FINAL PLAT

PEARSON FARMS ADDITION

Re: Final Plat S/D 88-24 - PEARSON FARMS ADDITION

STAFF REPORT
(Final Plat; Preliminary Approved 4/21/88)

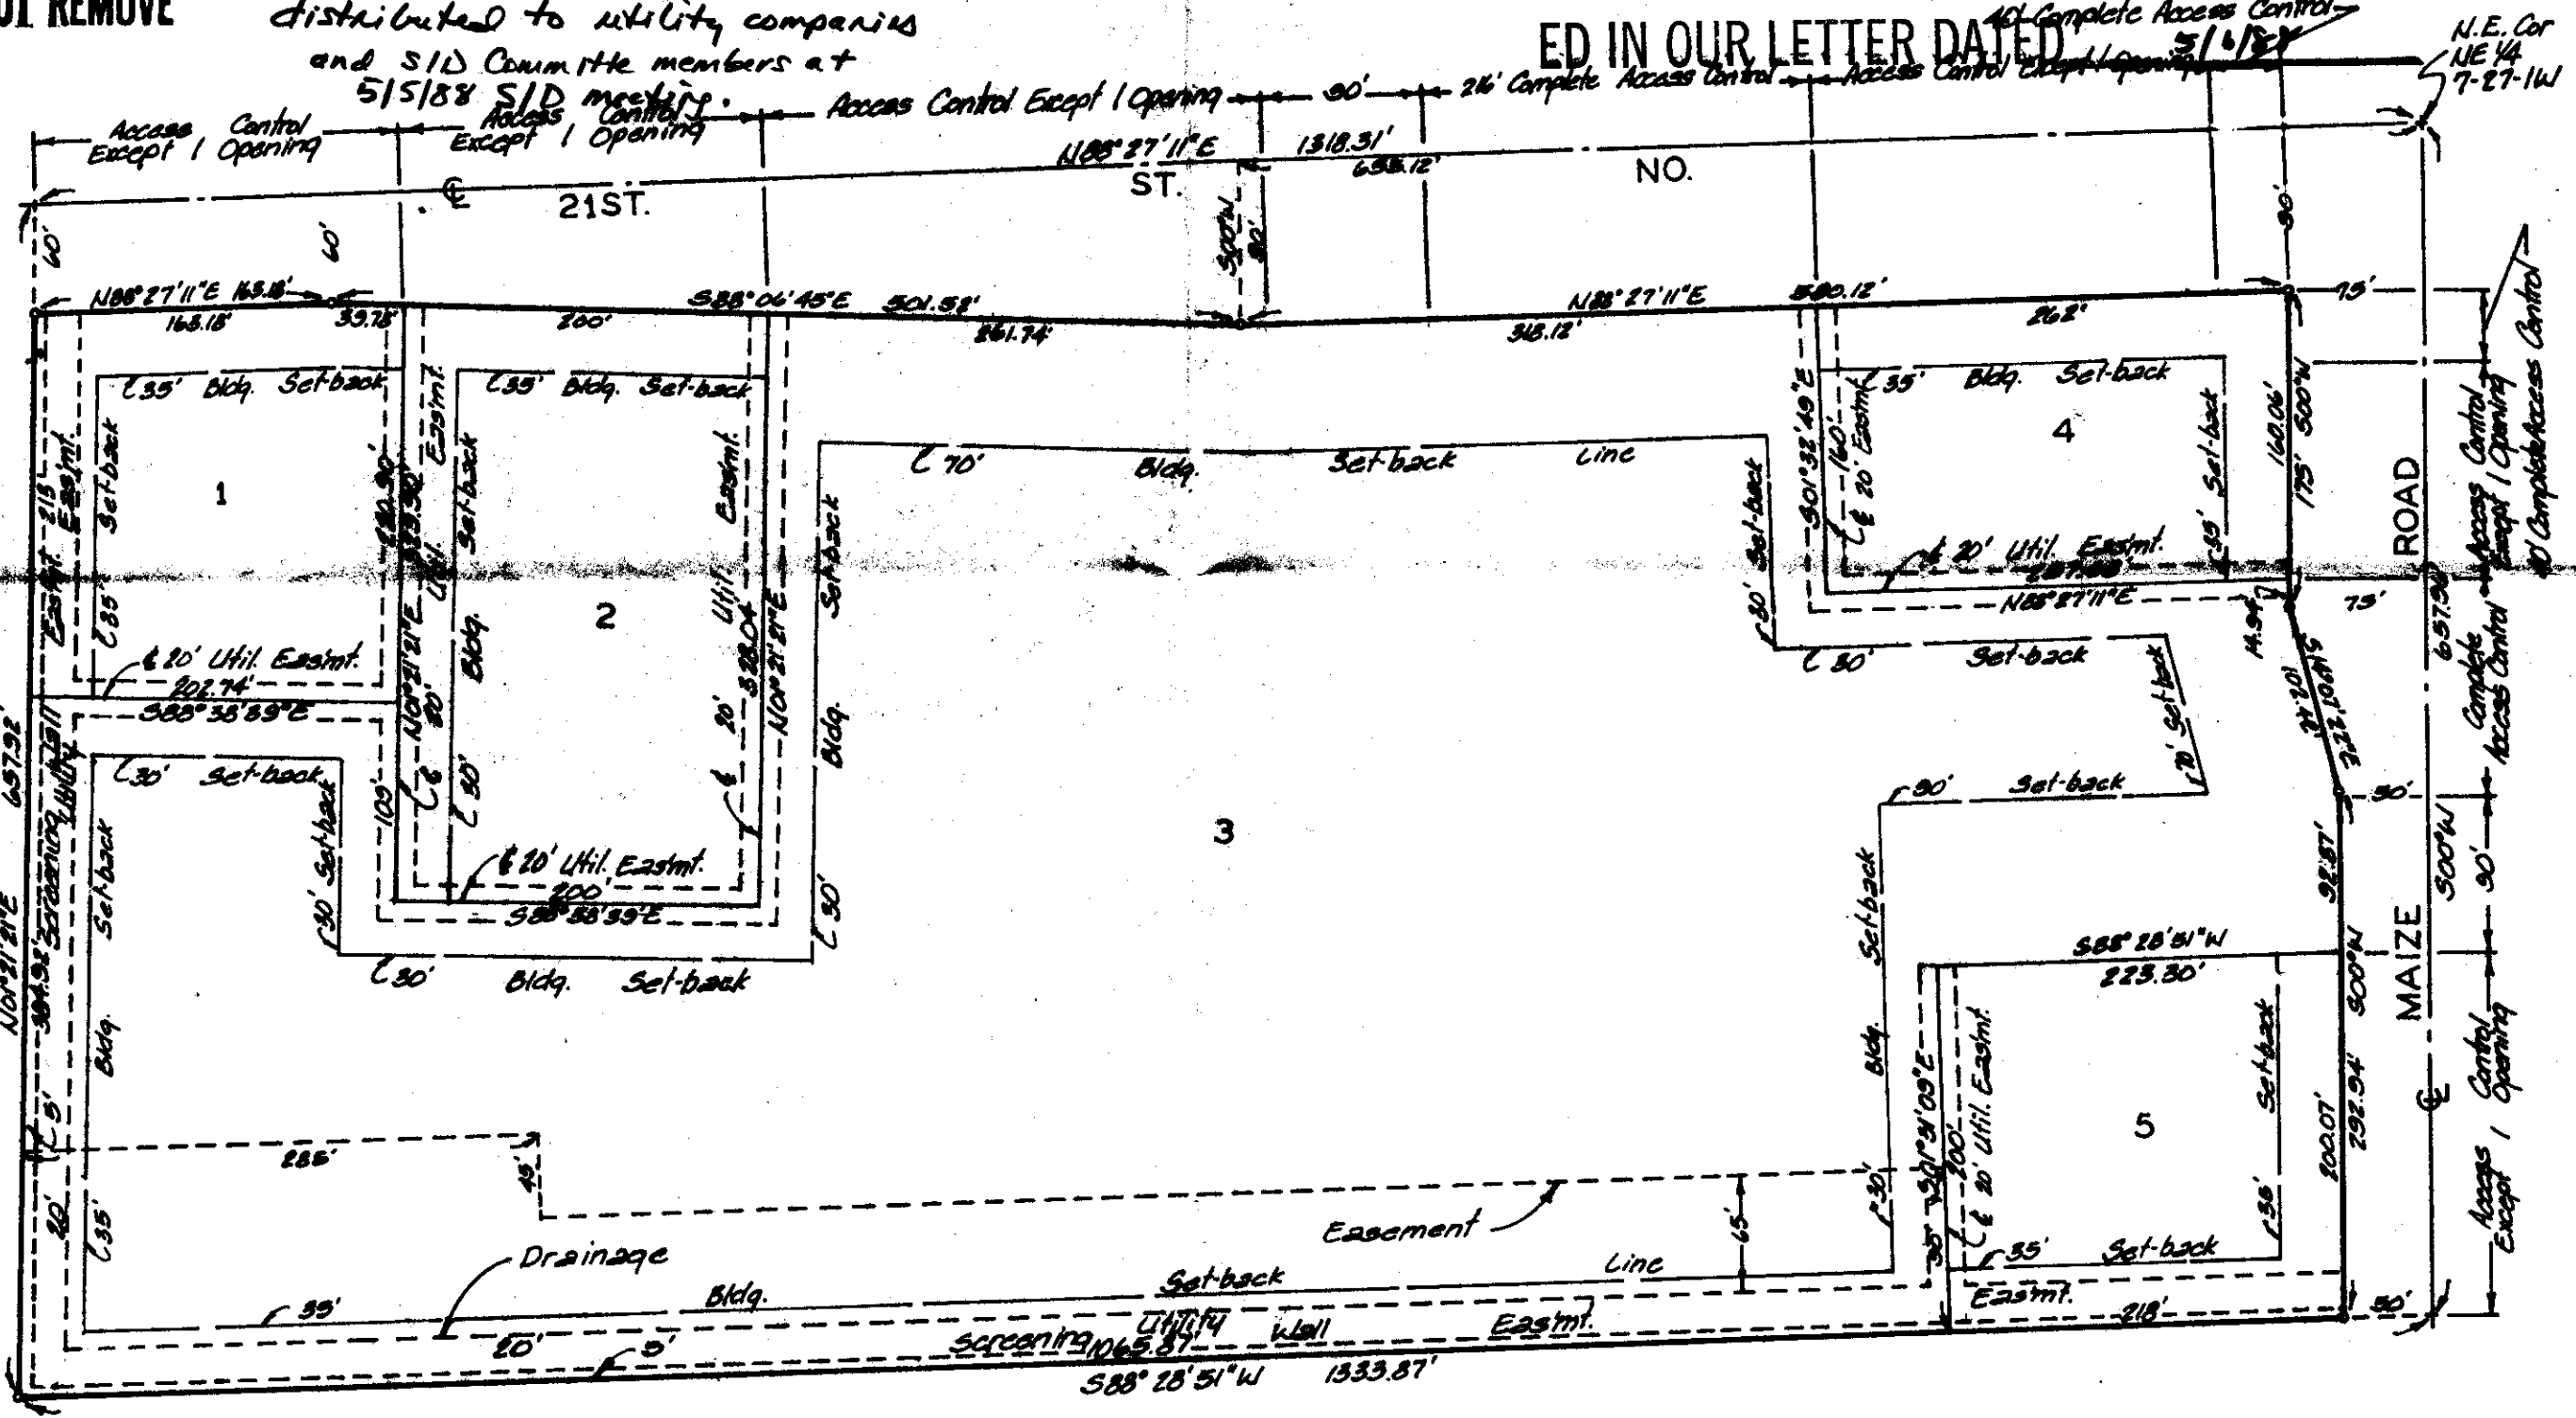
- I. The applicant shall obtain the off-site drainage agreement required by the drainage plan for this property.
- J. As required by the drainage plan for this property, the applicant shall submit a cross lot drainage agreement. This agreement shall provide for Lot 5 to drain across Lot 3.

- L. The final plat tracing shall indicate the utility easements requested by K.G.&E. and Southwestern Bell. These easements are indicated on the surveyor's copy of the approved preliminary plat.

- N. On the final plat tracing, the platlor's text shall be amended to more clearly indicate the access openings being allowed from the lots to Maize Road and 21st Street. In particular, the 90-foot areas from Lot 3, intended for major entrances, needs to be more accurately described. It is suggested that the platlor's text simply state that, "access controls as depicted on the face of the plat are hereby dedicated". Also, the 90-foot wide areas on Lot 3 should be labeled on the face of the plat as areas of "access control except for one opening".

- O. On the final plat tracing, the perimeter of Lot 2 shall be reduced to match the boundaries of C.U.P. Parcel 2. On the preliminary plat, the configuration of Lot 2 was correctly shown. If the applicant desires to plat Lot 2 as shown on this final plat, an adjustment to the Community Unit Plan parcel descriptions is required.

- P. Perimeter closure computations shall be submitted with the final plat tracing. Section 5-101(C).
- Q. Recording of the plat within 30 days after approval by the City Council.
